REMARKS

In the outstanding non-final Office Action of July 14, 2004, the Examiner objected to the drawings under 37 CFR 1.83(a) as allegedly not showing every feature specified in the claims; objected to the specification due to alleged informalities; rejected claims 2, 3, 10, 11, 18, 21, 25, 26, 29, 31, 32, and 35 under 35 U.S.C. 112, first paragraph as allegedly failing to comply with the enabling requirement; rejected claims 1, 4, 6-9, 12, 14-17, 19-20, 22-24, 27-28, 30, and 33-34 under 35 U.S.C. 102(e) as allegedly being anticipated by U.S. Patent No. 6,317,236 to Saunders; and rejected claims 5 and 13 under 35 U.S.C. 103(a) as allegedly being unpatentable over Saunders in view of U.S. Patent No. 6,128,313 to Chapman et al. ("Chapman"). Applicants traverse the objections and the rejections to the claims.

APPLICATION 09/752,828
ANNOTATED FIGURE

FIG. 5

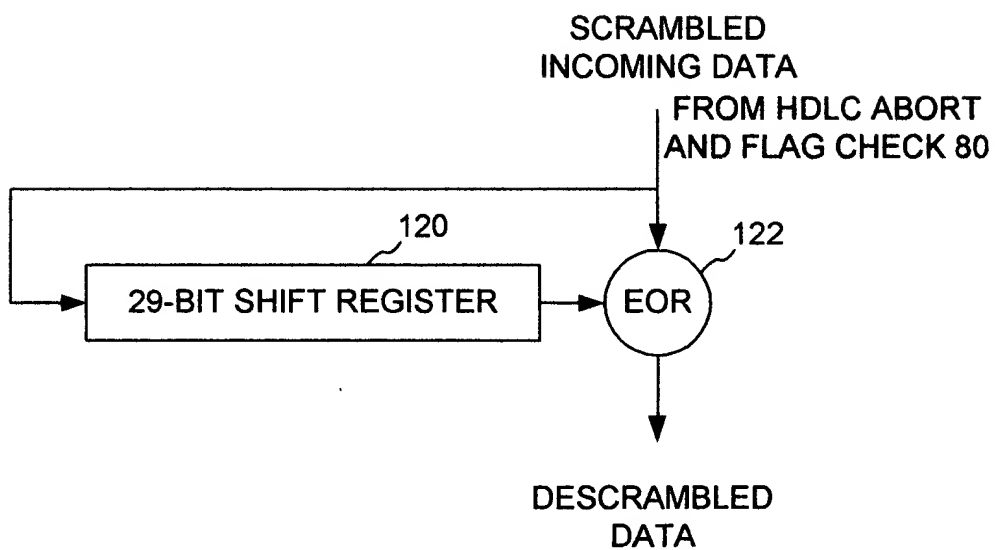
On page 2 of the Office Action, the Examiner objected to the drawings under 37 CFR 1.83(a) because the claim terms “an abort packet” of claim 2, “a runt packet” of claim 3, “an abort packet preparing element” of claim 10, “a runt packet preparing element” of claim of claim 11, “runt analyzer” and “discarding element” of claim 21, “an extractor” of claim 22, “creating an abort packet” of claim 25, “creating a runt packet” of claim 26, “abort packet element” of claim 31, “a runt packet element” of claim 33, and “a runt packet determining element” of claim 35 are not shown. The Examiner requested that the features be canceled from the claims or shown in the drawings.

With respect to Fig. 5, Applicants submit that the descrambling elements of Fig. 5 are not prior art. Fig. 5 shows the descrambling elements receiving scrambled incoming data from an HDLC abort and flag check. The prior art does not disclose the descrambling elements receiving scrambled incoming data from an HDLC abort and flag check.

With respect to “EOR” of Fig. 5, Applicants submit that the term “EOR” is a term well known to those of ordinary skill in the art as indicating an “exclusive-or” operation. The term “EOR” has not been changed in Fig. 5.

elements of HDLC descrambler 82, shown in Fig. 5, are not limited to only the elements shown in Fig. 5, but may contain additional elements.

With respect to page 8, line 29, Applicants, as discussed above, submit that the descrambling elements of Fig. 5 are not prior art. Fig. 5 shows the descrambling elements receiving scrambled incoming data from an HDLC abort and flag check. The prior art does not disclose the descrambling elements receiving scrambled incoming data from an HDLC abort and flag check. Further, Applicants submit that the descrambler of Fig. 5 is not limited to that which is disclosed in Merchant. Therefore, a reference to the Merchant reference has not been included in the specification.
